REVISED STATEMENT OF ENVIRONMENTAL EFFECTS

**FOR THE DEMOLITION OF THE EXISTING DWELLING AND
CONSTRUCTION OF A NEW DWELLING**

89 MARINE PARADE, AVALON BEACH

**Revised
May 2024**

Fig 15: Plan noting amended proposed works in blue and existing dwelling footprint in black outline

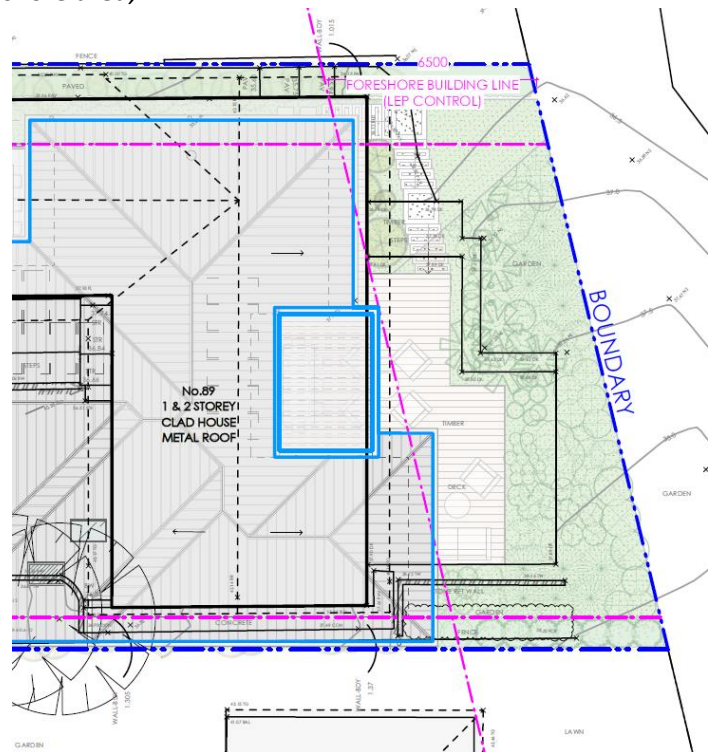
2. Development within foreshore area

Clause 7.8 (Limited development on foreshore area) of the PLEP 2014

The proposal involves elements of the development that are inconsistent with the following provisions of Clause 7.8:

(2) Development consent must not be granted for development on land in the foreshore area except for the following purposes—

(a) the extension, alteration or rebuilding of an existing building wholly or partly in the foreshore area, but only if the development will not result in the footprint of the building extending further into the foreshore area.

- The amended rear terrace/deck area is amended to fit within the existing rear terrace/deck footprint
- The amended stair leading down to the northern side boundary has been relocated and now is within the existing stair footprint
- The amended adjustable louvre pergola has been relocated so it fits entirely outside the foreshore area, a reduction of 12m² of louvred pergola area.
- The narrow terrace opening off from the Living Room in the North East Corner has been amended to have a 2.5 metre side boundary setback, is built within the existing building footprint and fits entirely outside the foreshore area, except for a small triangular section on the North-East corner, 0.85 metres x 3.6 metres = 1.53m²

- The amended Home Office to the Lower Ground Floor has been reduced in depth to fit entirely outside the foreshore area
- There are no retaining walls within the Foreshore area
- The conversation pit originally proposed within the foreshore area has been removed
- The submission is accompanied by a Written Request under Clause 4.6 of the Pittwater Local Environmental Plan 2014 in relation to the minor new work extending forward of the foreshore building line, which is restricted to the new eave overhang to the east of the sitting room.

The design intent is to ensure that the extent of the new work is contained wholly within the existing built footprint of the dwelling and decking (See Figure 14 below) located forward of the foreshore building line, consistent with the provisions of clause 7.8(2)(a) which note:

The proposal will provide for the rebuilding of the existing building observing the existing extent of work within the foreshore area and maintaining the existing location of the dwelling at its north-eastern corner.

The proposal will see a minor encroachment of an eave which stands over existing decking and presents a new element of the building forward of the foreshore line. This portion of the building provides for solar protection for the dwelling and provides an important environmental benefit to the dwelling and on this basis, a Written Request under clause 4.6 of the Pittwater Local Environment Plan 2014 has been prepared to address the minor non-compliance with the foreshore building line control.
